ITW Building Components Group, Inc.

Truss Fabricator: Anderson Truss Company

Job Identification: REPAIR/7-140B

TRUSS REPAIR

Refer to drawing HCUSR8228 07353141 (C1)

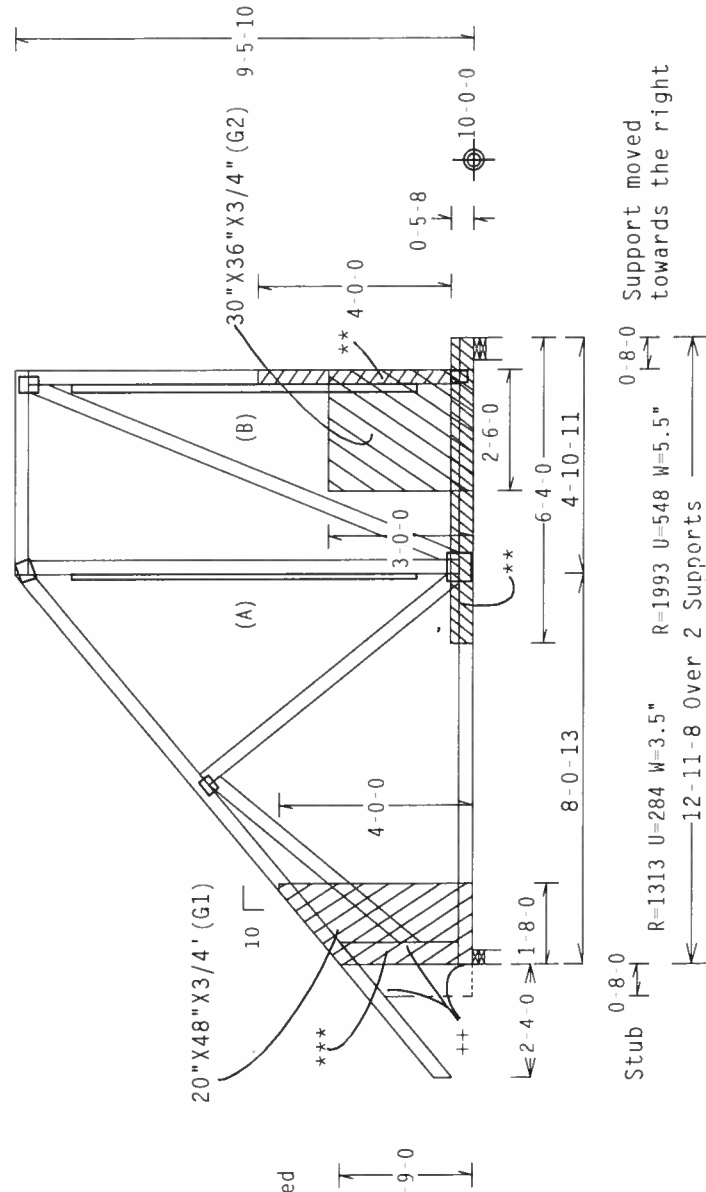
This truss is repaired to extend bottom chord 0-8-0 on the right end and stub truss 0-8-0 on left end as shown.

** Field applied spider jack,

(2) - 2X6X(6-4-0) SP #2 DENSE OR BETTER SCABS.

to each outer face of chord with 1-Row of

10d(0.148"X3.0") COMMON NAILS @ 4.0" O.C.

(2) - 2X4X(4-0-0) SP #2 OR BETTER SCABS.

ATTACH EACH SCAB TO FACE OF THE VERTICAL,

SNUG AND TIGHT AGAINST 2X4 SCAB WITH 1-R

10d(0.148"x3.0") COMMON NAILS @ 4.0" O.C.

++ USE A SHARP METAL CUTTING SAW BLADE TO CAREFULLY REMOVE MATERIAL FROM THE TRUSS AS SHOWN. REMAINING PORTIONS OF TRUSS AND ALPINE PLATES MUST BE FREE FROM DAMAGE AND FULLY EMBEDDED INTO TRUSS MEMBERS.

*** (1) - 2X6X(SCRIBE TO CUT FOR TIGHT FIT) SP #2 OR

BETTER FIELD APPLIED MEMBER, in plane with

truss. Note: New (1)-One new 2x6 field applied

vertical web.

Refer to drawing HCUSR8228 07353178 (C3)

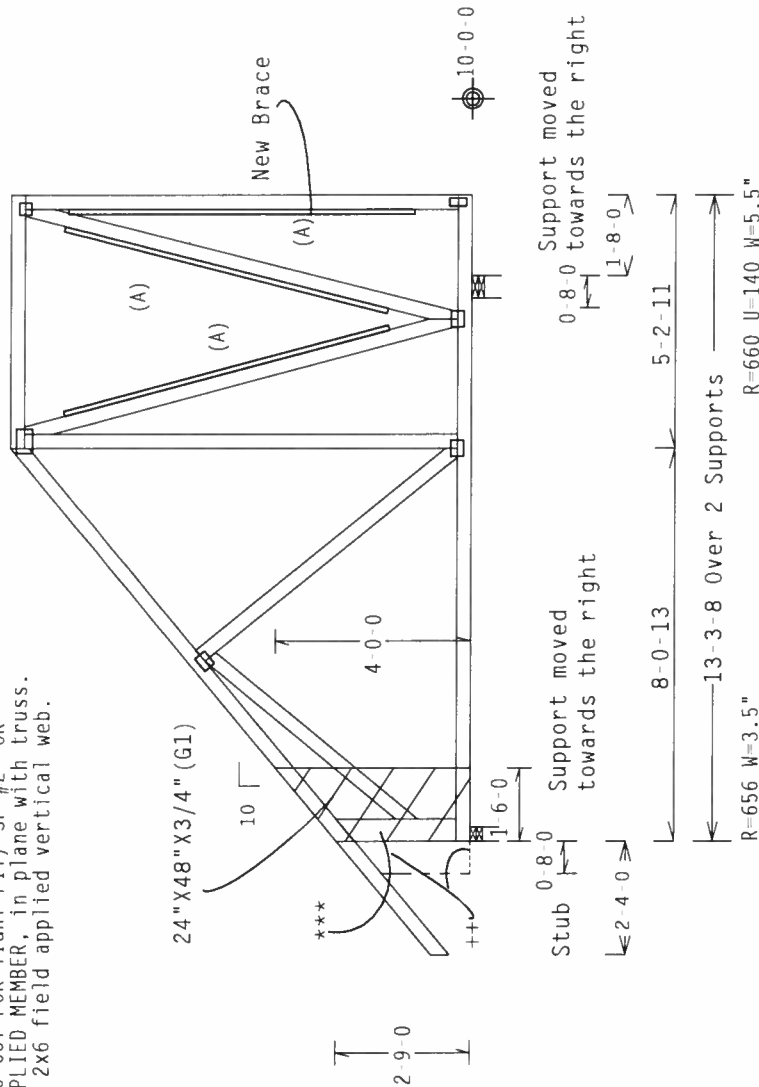
This truss is repaired for right support moving 0-8-0 towards the right and to stub truss 0-8-0 on left end as shown.

++ USE A SHARP METAL CUTTING SAW BLADE TO CAREFULLY REMOVE MATERIAL FROM THE TRUSS AS SHOWN. REMAINING PORTIONS OF TRUSS AND ALPINE PLATES MUST BE FREE FROM DAMAGE AND FULLY EMBEDDED INTO TRUSS MEMBERS.

*** (1) - 2X6X (SCRIBE TO CUT FOR TIGHT FIT) SP #2 OR BETTER FIELD APPLIED MEMBER, in plane with truss.
Note: New (1) - One new 2x6 field applied vertical web.

(A) 1x4 #3 or better "T" brace. 80% length of web member. Attach with 8d Box or Gun (0.113"x2.5", min.) nails @ 6" OC.

(G1) 3/4" Gusset Plates are C-D EXT APA RATED 40/20 SHEATHING, (Plywood or OSB). Apply gusset to each face of truss and attach with evenly distributed 6d Common or Gun (0.113"x2.0", min.) nails in 1-row @ 2.0" OC throughout chords, webs and new field (***) applied members.

Refer to drawing	HCUSR8228	07353173	(C4)
drawing	HCUSR8228	07353177	(C2)

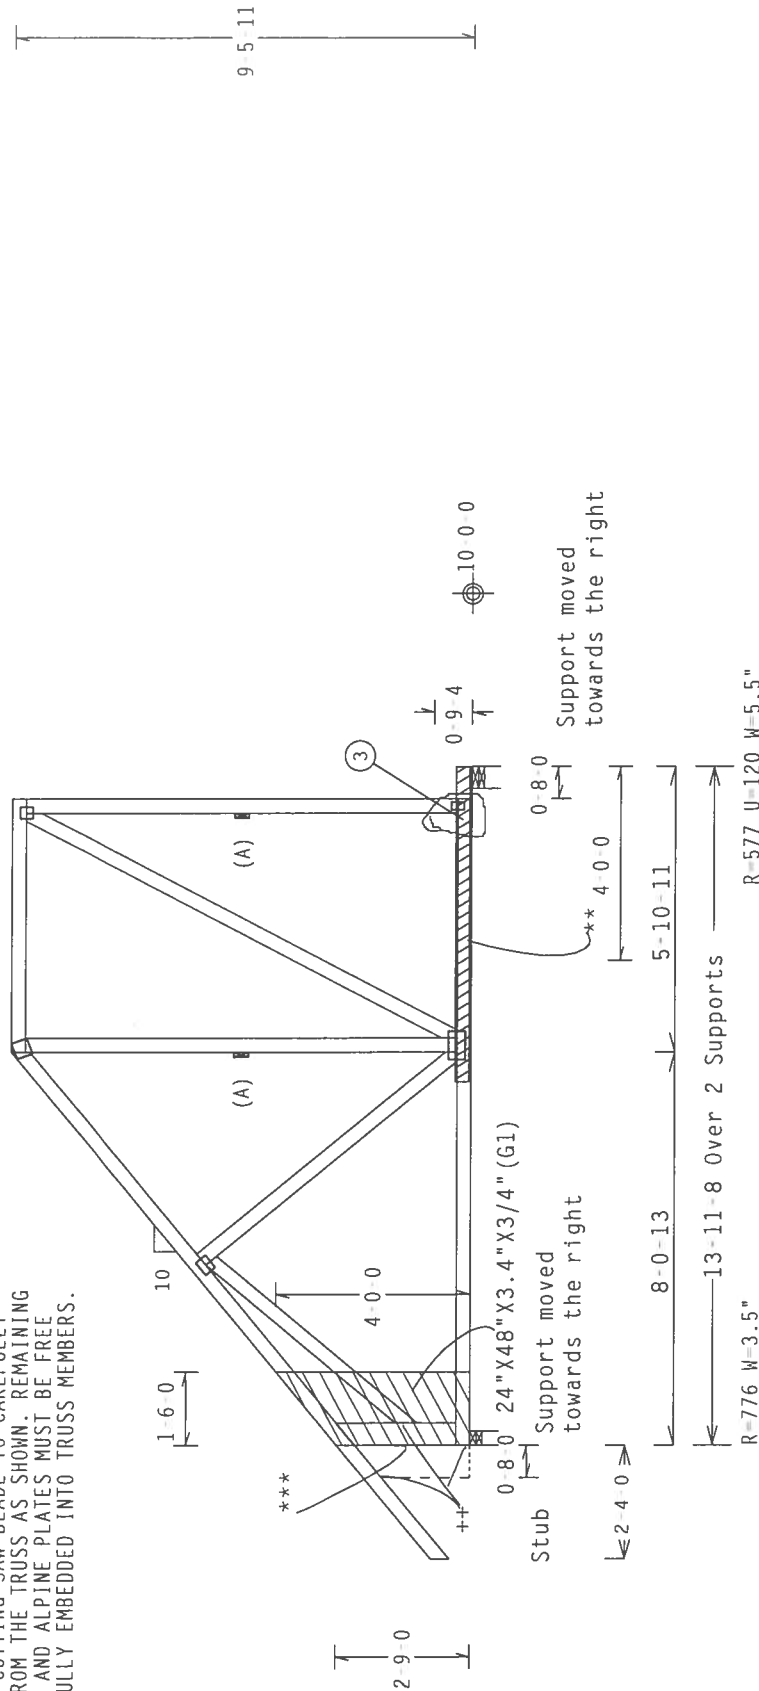
This truss is repaired to extend bottom chord 0-8-0 on the right end and stub truss 0-8-0 on left end as shown.

*** (1) 2X6X(SCRIBE TO CUT FOR TIGHT FIT) SP #2 OR

BETTER FIELD APPLIED MEMBER, in plane with truss.
Note: New (1) - One new 2x6 field applied vertical web.

++ USE A SHARP METAL CUTTING SAW BLADE TO CAREFULLY REMOVE MATERIAL FROM THE TRUSS AS SHOWN. REMAINING PORTIONS OF TRUSS AND ALPINE PLATES MUST BE FREE FROM DAMAGE AND FULLY EMBEDDED INTO TRUSS MEMBERS.

** (2) - 2X4X(6-6-0) SP #2 OR BETTER SCABS.

ATTACH EACH SCAB TO FACE OF THE BOTTOM CHORD, WITH 1-ROW OF 10d(0.128"x3.0") COMMON NAILS @ 4.0" O.C. offset row from opposing faces to prevent splits. In addition, (3) each 10d Box (0.128"x3.0", min.) nails near right as shown circled.

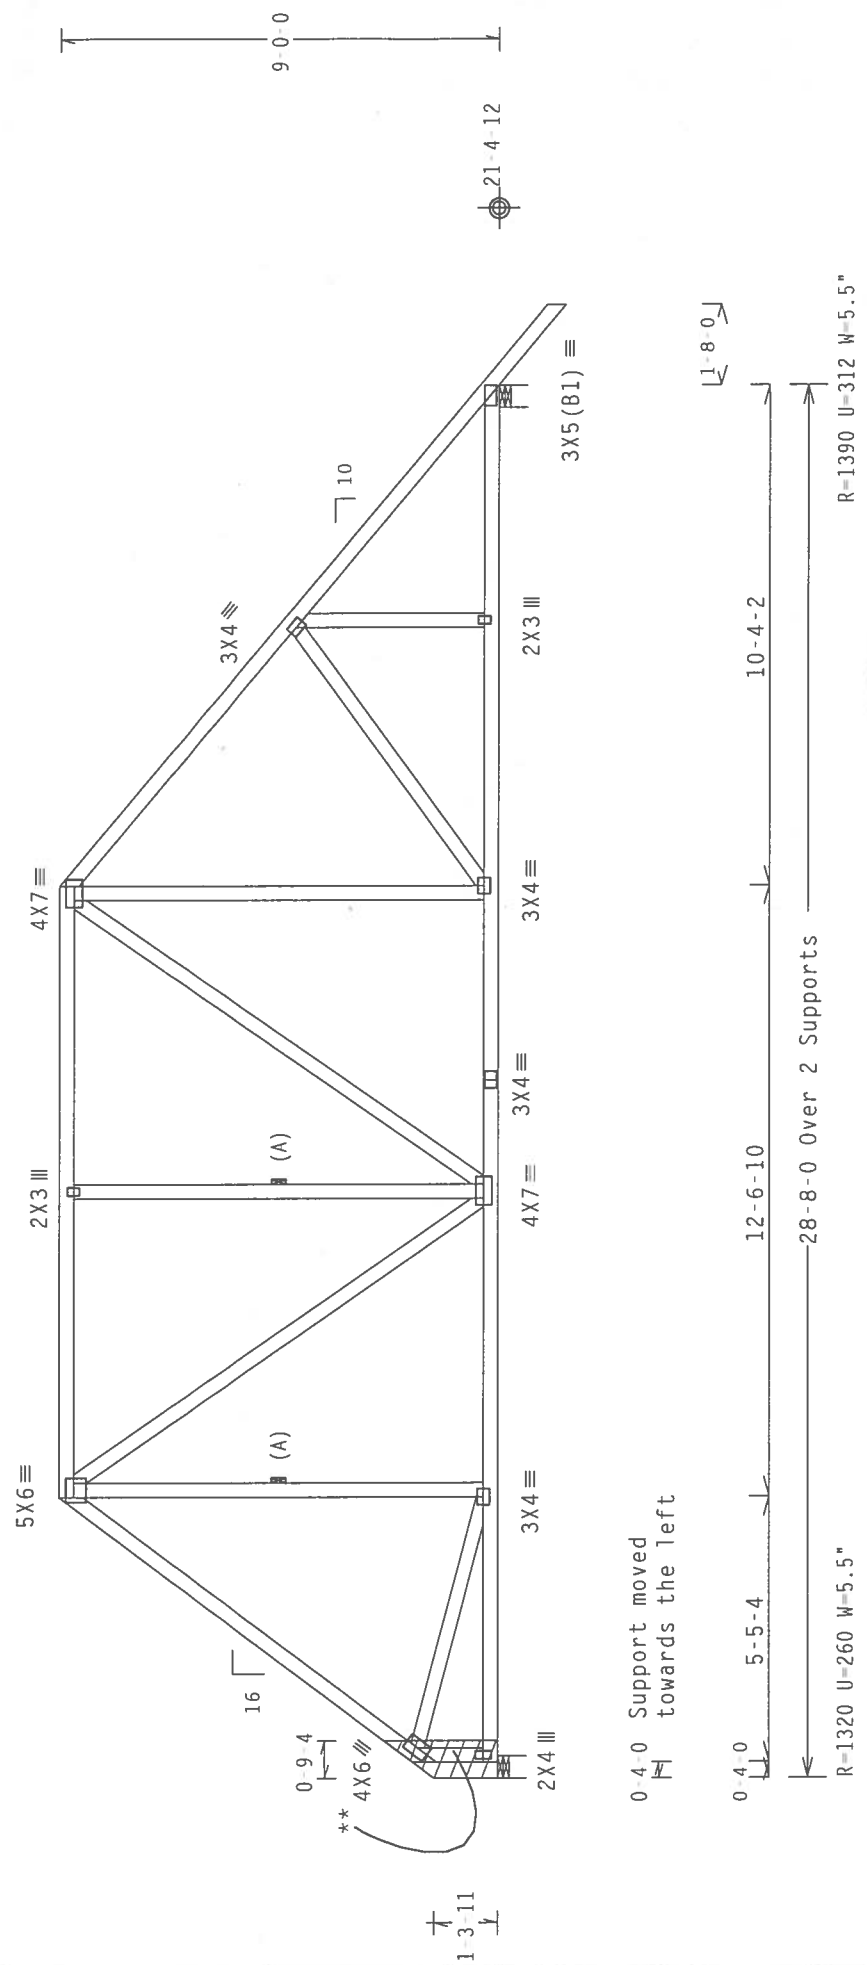
This truss is repaired for left support moving 0-4-0 towards the left as shown.
Refer to drawing HCUSR8228 07353103 for plates and other data not given here.

** (2) 2X10X (Profile cut to fit tight) SP #2 OR BETTER SCABS. ATTACH EACH SCAB TO FACE OF THE VERTICAL AND TOP AND BOTTOM CHORD, SNUG AND TIGHT AGAINST SUPPORT WITH 1-ROW OF 10d (0.128"x3.0") COMMON NAILS @ 2.5" O.C.

Refer to drawing HCUSR8228 07353093 (B3)

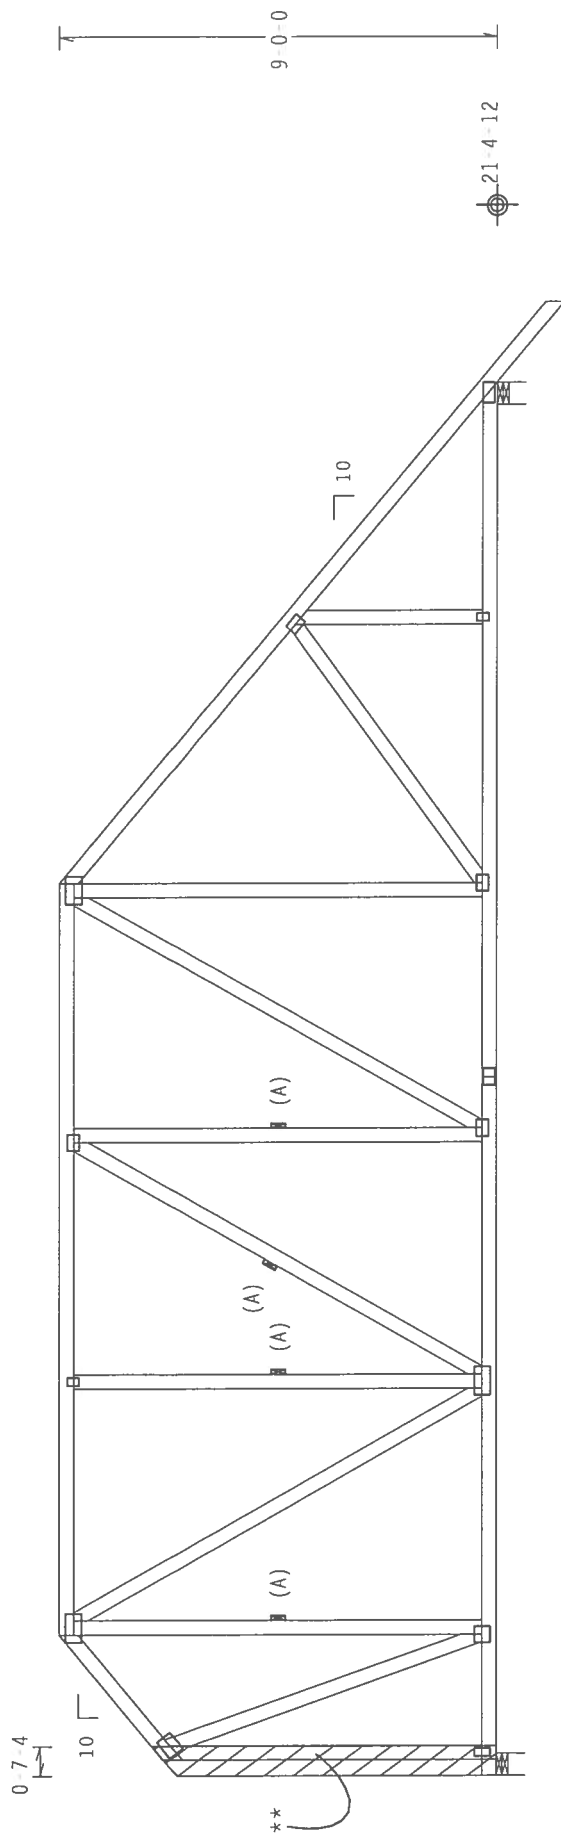
This truss is repaired for extend bottom chord 0-4-0 on the left end of truss as shown.

2X8X(Profile cut to fit tight) SP #2 OR BETTER SCABS.

ATTACH EACH SCAB TO FACE OF THE VERTICAL
BOTTOM CHORD, SNUG AND TIGHT AGAINST SUPPORT WITH 1-ROW OF
10d(0.148"x3.0") COMMON NAILS @ 4.0" O.C.

0-4-0 N Support moved towards the left
